## Sandleford Park, Newbury

### APP/36: Lee Witts' rebuttal to Jon Bowden's Proof of Evidence

21<sup>st</sup> April 2021

## Appendix D – Review of Ground Water Mapping against Alternative Drainage Strategy 2 (10309-SK-08)

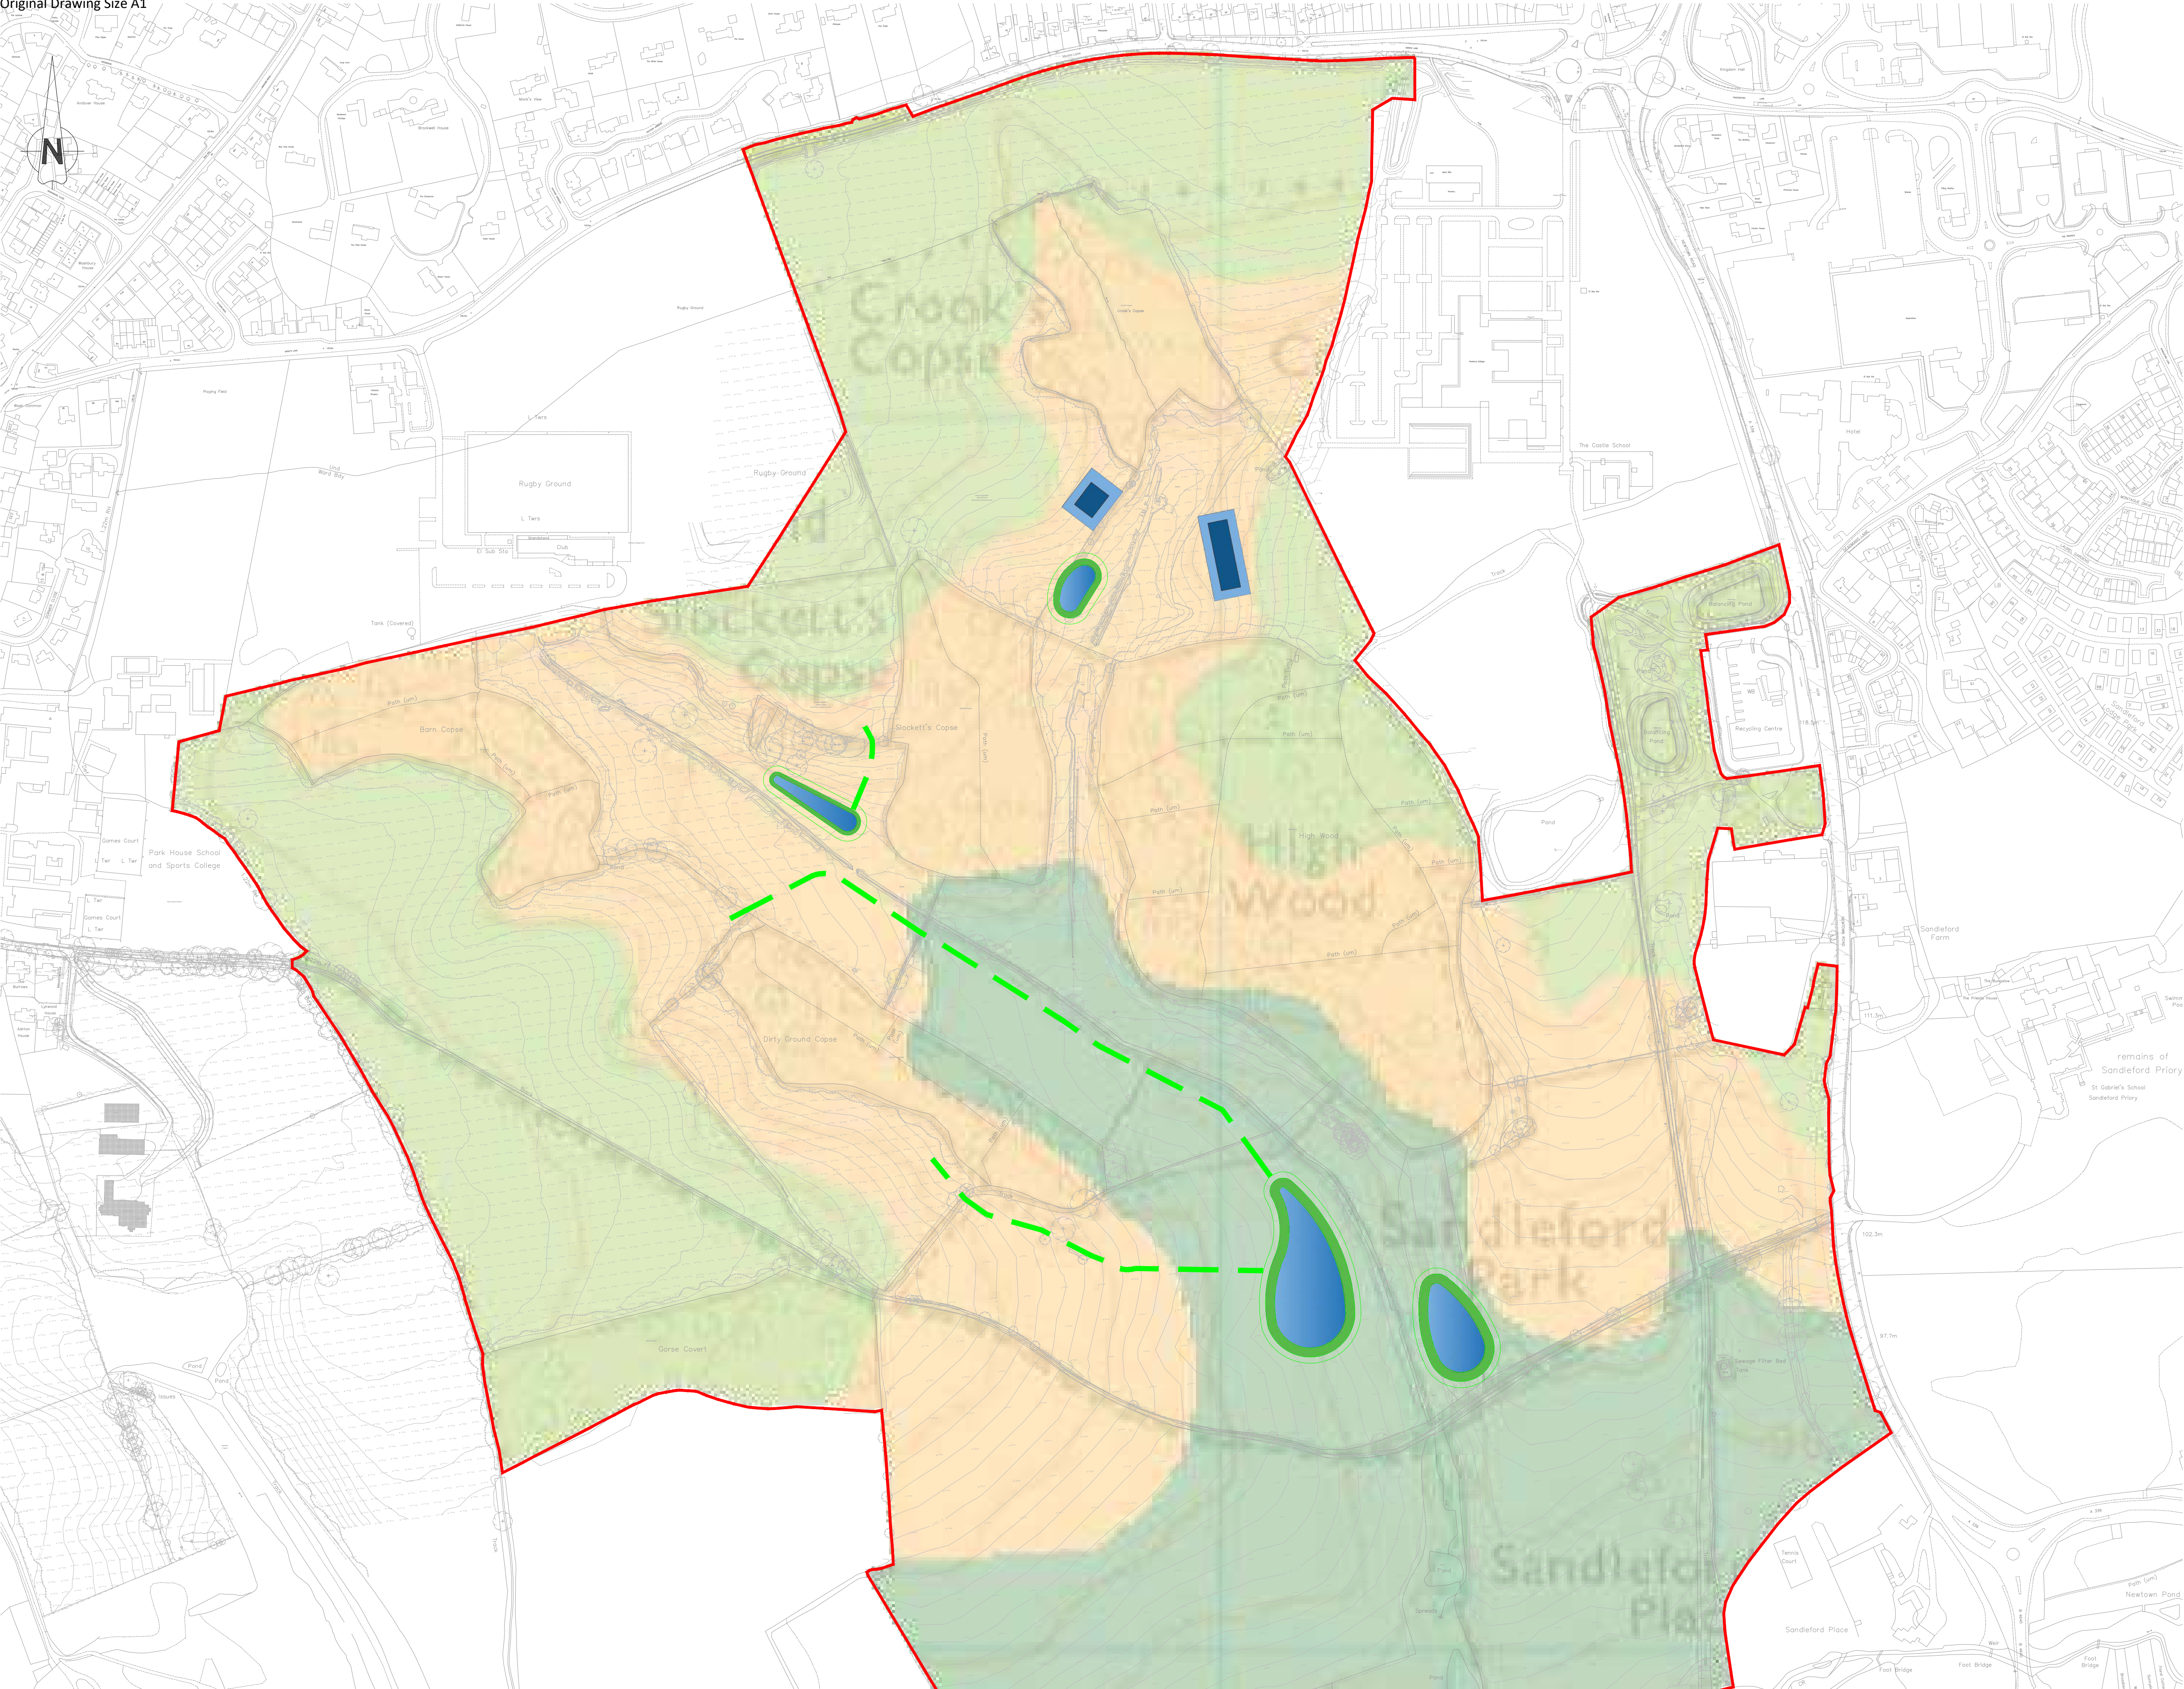
**Appendix A** – Review of Ground Water Mapping against Site Topography  
**Appendix B** – Review of Ground Water Mapping against Original Drainage Strategy  
**Appendix C** – Review of Ground Water Mapping against Alternative Drainage Strategy 1  
**Appendix D** – Review of Ground Water Mapping against Alternative Drainage Strategy 2
- 1.22 Firstly, groundwater does not slope parallel to the topography of the surface. Groundwater can only drop abruptly in the presence of a geological fault. However, there is no evidence that there is such a fault that occurs within the site boundary. Because of this there will not be such an immediate and dramatic change in groundwater levels due to a change in geology. The levels will rise or fall gradually across the site.

Drainage Strategy was issued as 10309-DR-04 A within APP/17 Appendix E.
